Appln No. 09/955,693

Reply to Office action of December 10, 2004

Amendments to the Drawings:

REMARKS/ARGUMENTS

Figure 1

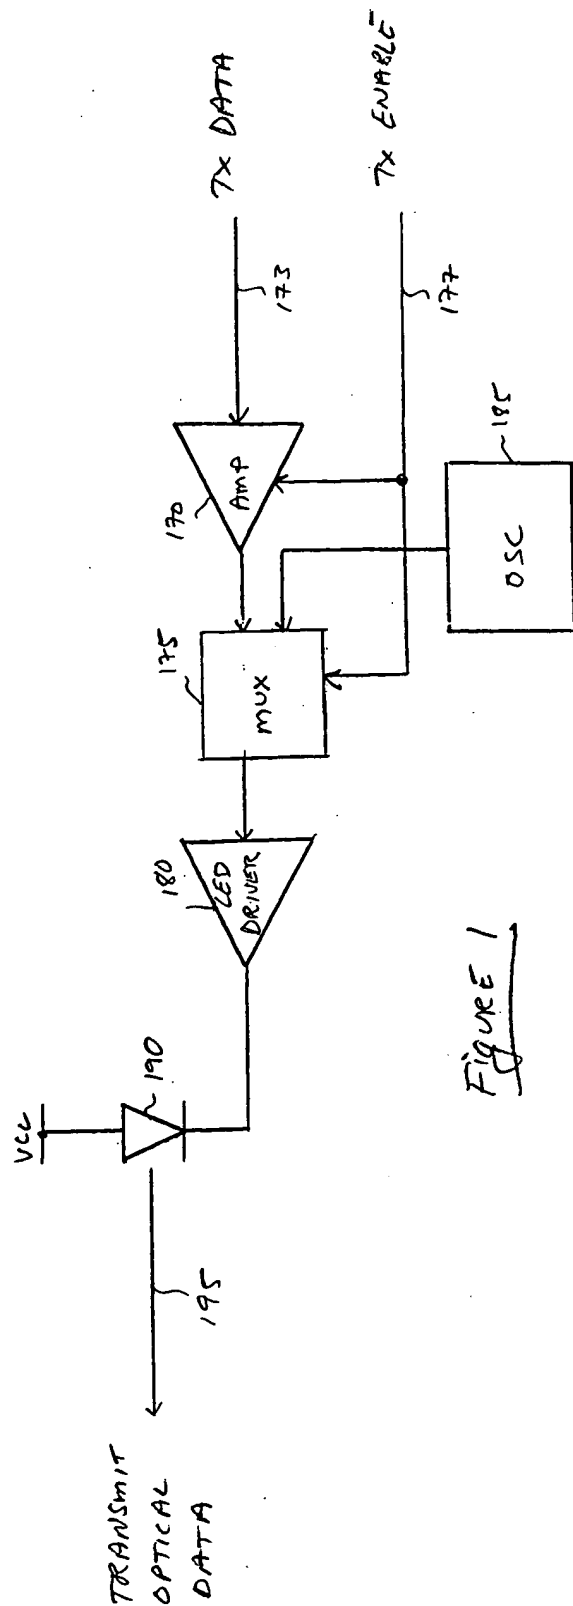
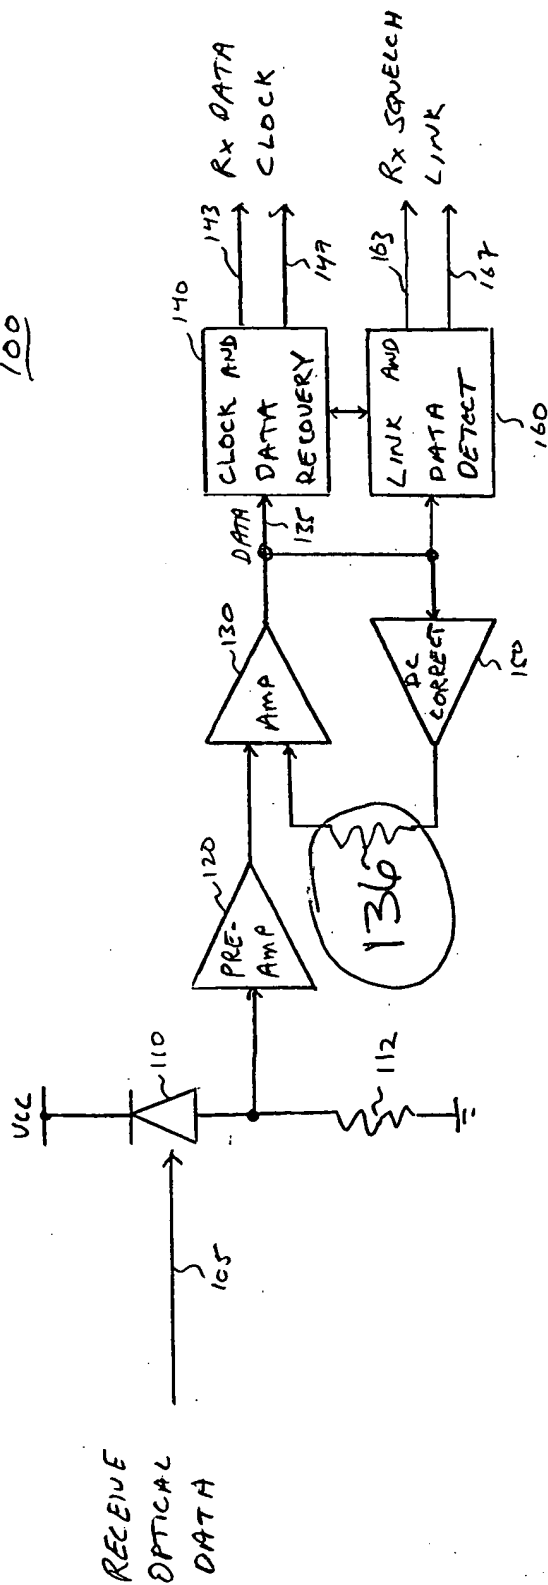
Figures 1, 4A, 5, 6, and 13 are objected to for labeling errors. These figures have been amended to address the objections and correct the errors.

The attached sheets of drawings include changes to Figures 1, 4A, 5, 6, and 13 of this Application. These sheets, which include Figures 1, 4A, 5, 6, and 13 replace the original sheets including Figures 1, 4A, 5, 6 and 13.
